# AEB IWG 13 – Industry Input

Why use “perpendicular” also for the pedestrian scenario?

„perpendicular“

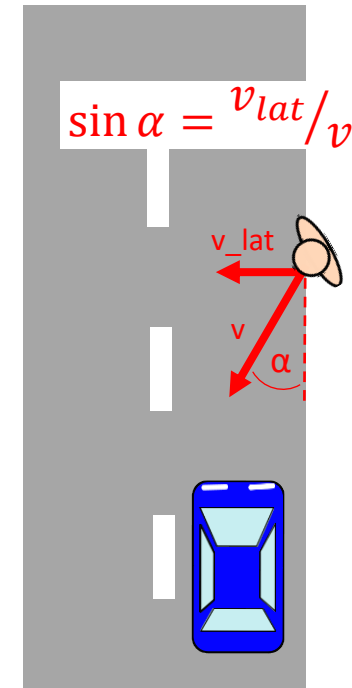
- ▶ **Goal:** Create an unambiguous regulation -> use same wording as for Car2Bicycle.
- ▶ **Problem:** Because the crossing angle is currently undefined, the performance requirement applies to completely different scenarios

„much more likely that the pedestrian will not enter the road“

### (b) Objects can be outside of the field of view while the vehicle is turning

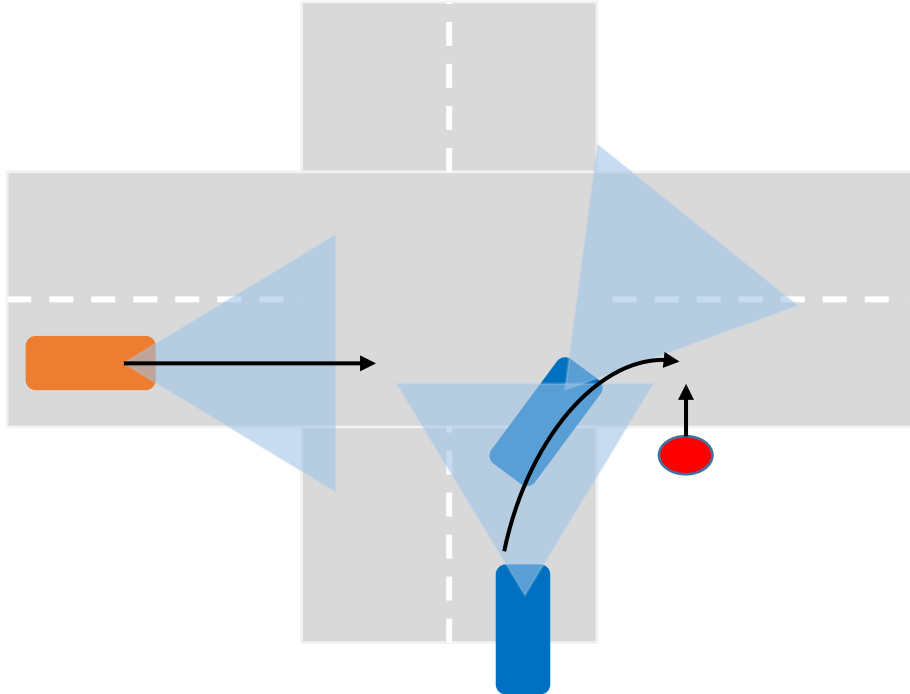
- The field of view of the sensors is primarily directed to the front of the vehicle in order to detect critical situations coming up ahead.
- When the vehicle is turning, the critical situations develops to the side of the vehicle and therefor outside of the AEB's detection area, which prevents the AEB from initiating an emergency braking.

- (h) In absence of **extreme highly dynamic** driving conditions (e.g. harsh cornering).
- (i) **In absence of turning events (e.g. at an intersection) affecting the system performance**
